**WHITE LAKE TOWNSHIP
INTER-OFFICE MEMORANDUM
COMMUNITY DEVELOPMENT DEPARTMENT**

**SUBJECT: Ginko Self Storage
Amended Final Site Plan**
located on the north side of White Lake Road, west of Old White Lake Road, consisting of 2.14 acres. Currently zoned Light Manufacturing (LM). Identified as vacant parcel 12-01-127-004
Applicant: Ginko Investments, LLC

RE: **Ginko Self Storage -Final Site Plan/Final Engineering Plan Review-4th Review**
~~Stormwater Maintenance Agreement Review-1st Review~~

Revised Final Site Plan Review for Special Land Use for White Lake Charter Township, Michigan

GRADING PLAN

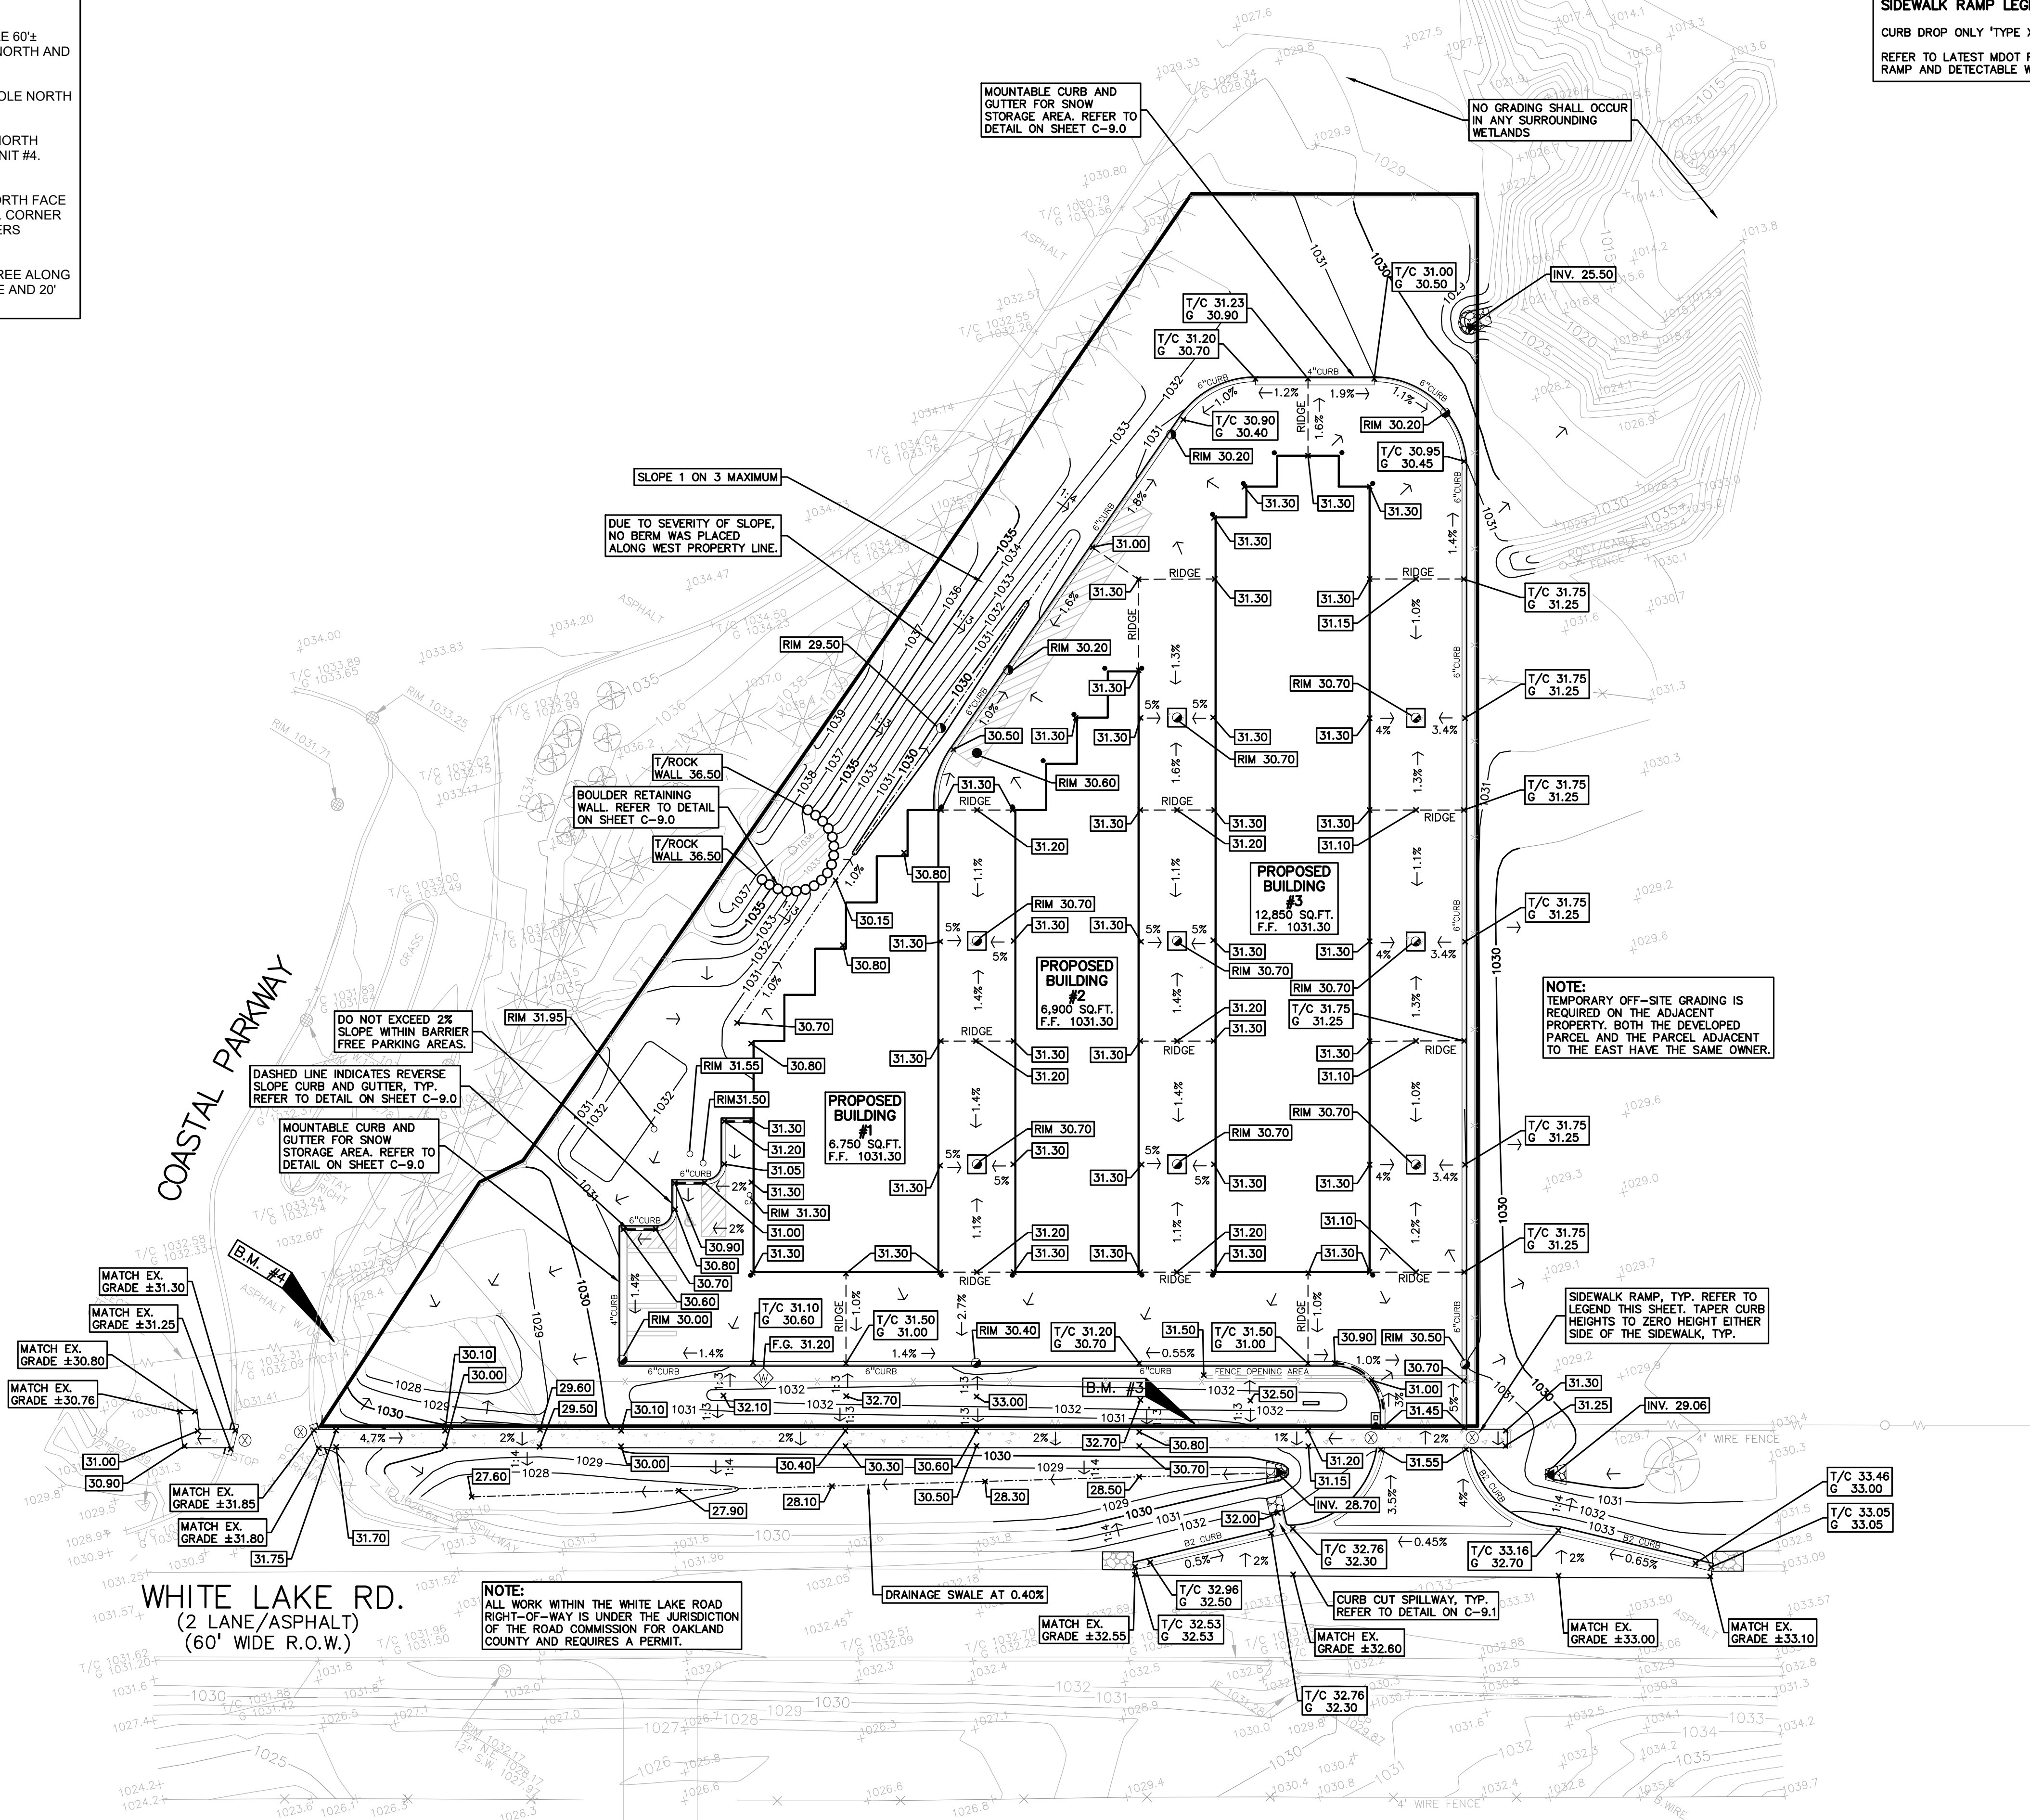
1. Sheet C-3.0- Striped crosswalk at drive entrance has now been eliminated. Is this the intent or is this in error?
2. Sheet C-4.0- Provide ADA parking blowup for this area; this was shown on the previous submittal.

3. Sheet C-4.0- What is the top of rock wall grade on the east side toward Building #1? Previously, this was shown as 31.50'. Please clarify grade intent in this area as well as provide T/W and B/W elevations at regular intervals for wall.

4. Sheet C-4.0- SW corner of site- Drainage will collect in a hole (1028) in this area. Provide a positive outlet for drainage in this area.
5. Sheet C-4.0- Easternmost edge of sidewalk – Locations of grades 31.30 and 31.25 as well as drainage arrow seem reversed based on proposed contours to the east.

6. Sheet C-4.0-Proposed drainage swale in ROW and to the south of proposed sidewalk along White Lake Road- Drainage in this area will collect at the low point of 27.60 and will pond within the entire 1029 contour until drainage spills over at the existing 1029.64 ES invert. This will cause flooding of a portion of the proposed sidewalk (at 29.50/29.60) and could lead to spillover on the sidewalk into the 1028 on-site low point (see Comment 4 above) with additional drainage accumulating. Previous plan set showed a different grade for the existing culvert under Costal Parkway, did this change?
